TO: MTA BOARD OF DIRECTORS
FROM: STANLEY G. PHERNAMBUCO 
SUBJECT: MTA CONSTRUCTION NONCONFORMANCE REPORTS

Attached please find copies of the Nonconformance Reports (NCRs) received by the MTA Director of Quality Management for the period of February 9-15, 1996.

CIDH Pile #399 @ Sta. 399 + 57.85
REDRAWN FROM GENCO SKETCH

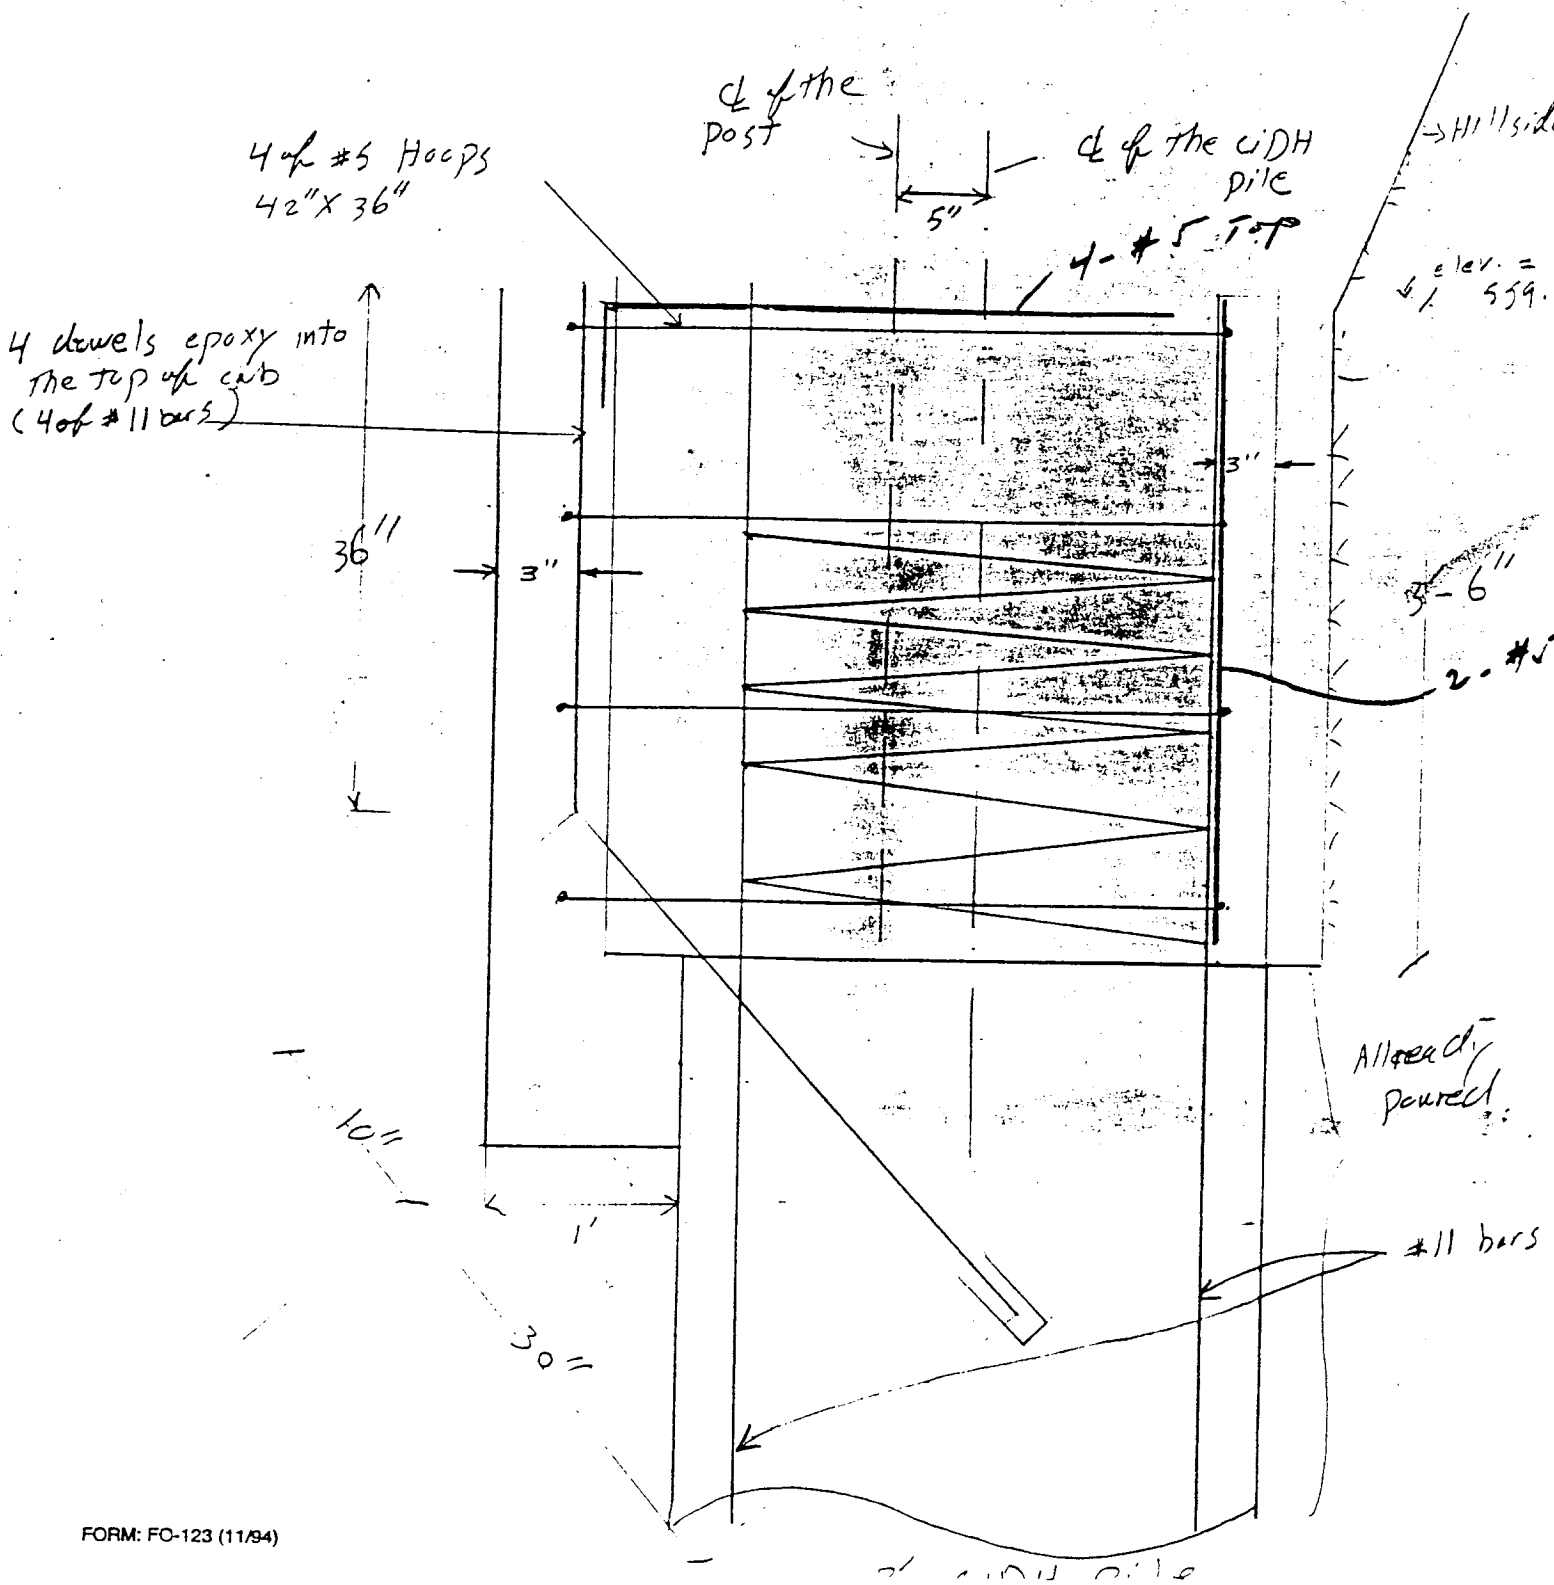
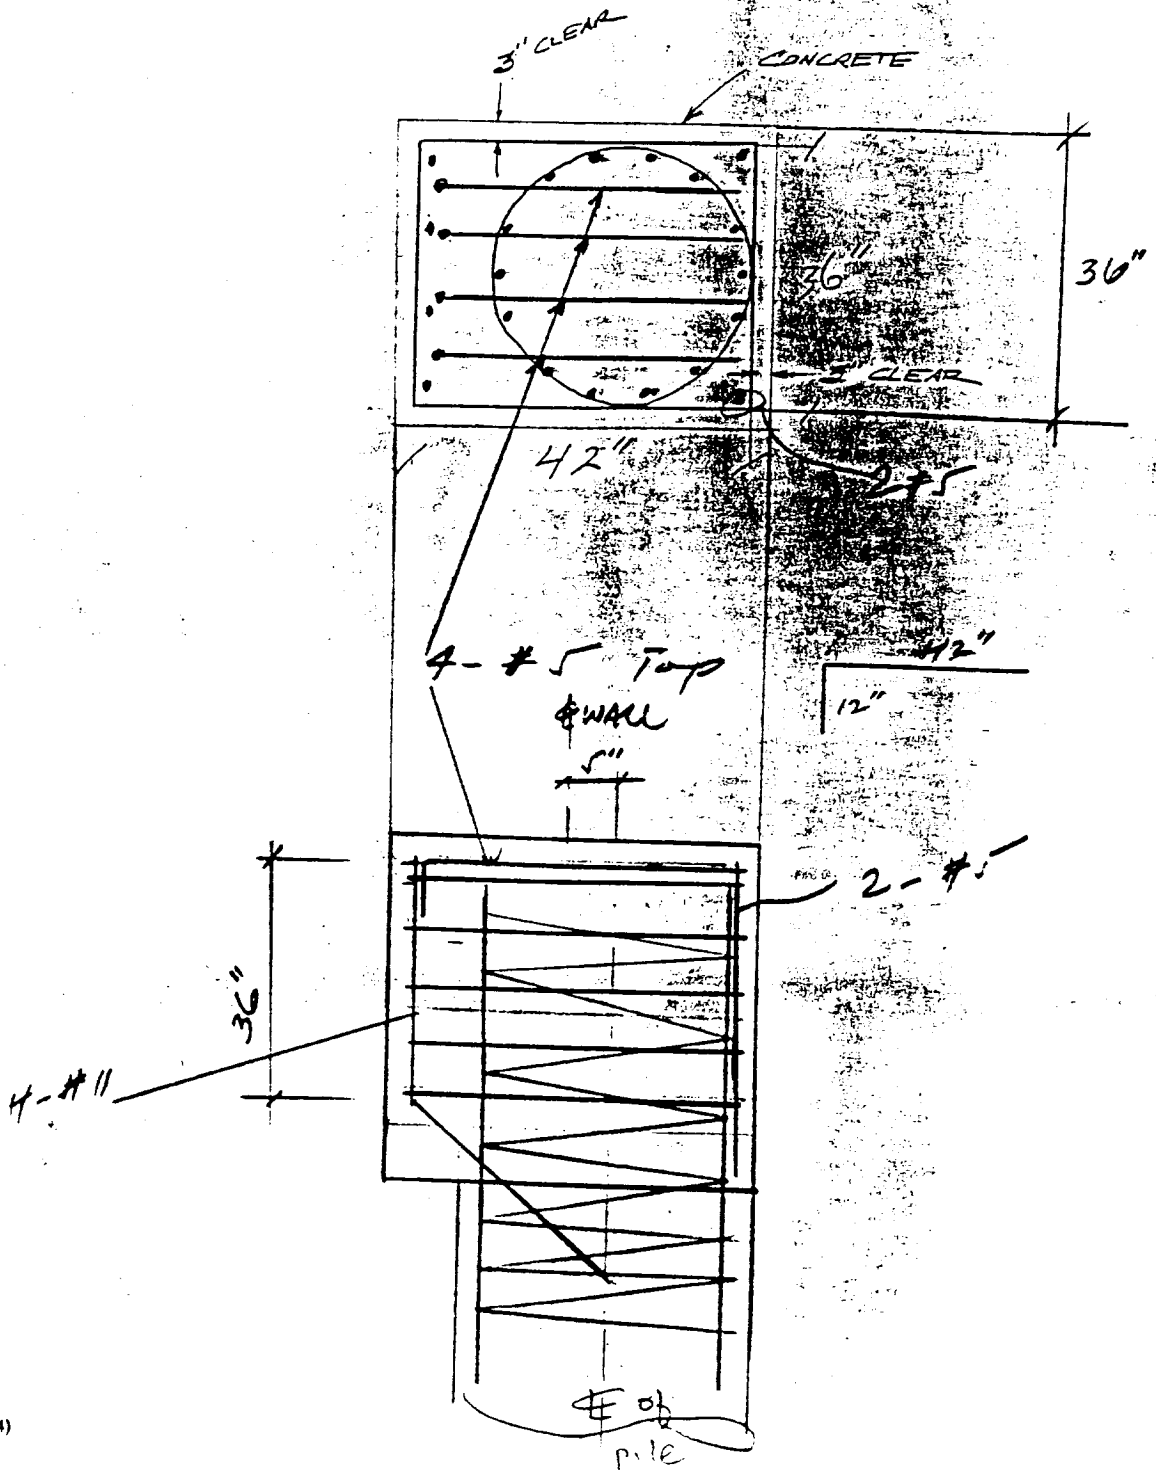
9. Nonconformance description and contract requirements: THE ABOVE LISTED PILE IS IN VIOLATION OF THE ALLOWED 3" TOLERANCE AS SPECIFIED IN SECTION 02387-1. 2 E. 1.b

14. Corrective action(s) to prevent recurrence (completed by contractor):
THE SUBCONTRACTOR, GENCE CORP., IS ALIGNING THE PILE CAGES BETWEEN THE OFFSETS PROVIDED. GENCE CORP. HAS OFFERED THE ATTACHED SOLUTION TO CORRECT PILE # 399.

19. Engineer Approval: See sketches for additional reb. etc.	Print Name: N. P. PANDYA	Signature: <i>N. P. Pandya</i>	Date: 10-23-95	20. Resident Engineer: <i>Tom C. Walker</i>	Date: 1/31/96
---	-----------------------------	-----------------------------------	-------------------	--	------------------

21. Verification that nonconforming condition has been corrected:
Pile # 399 N C R #20 all correction made per. EMC response
Work was completed on 12/29/95 see attached sheets
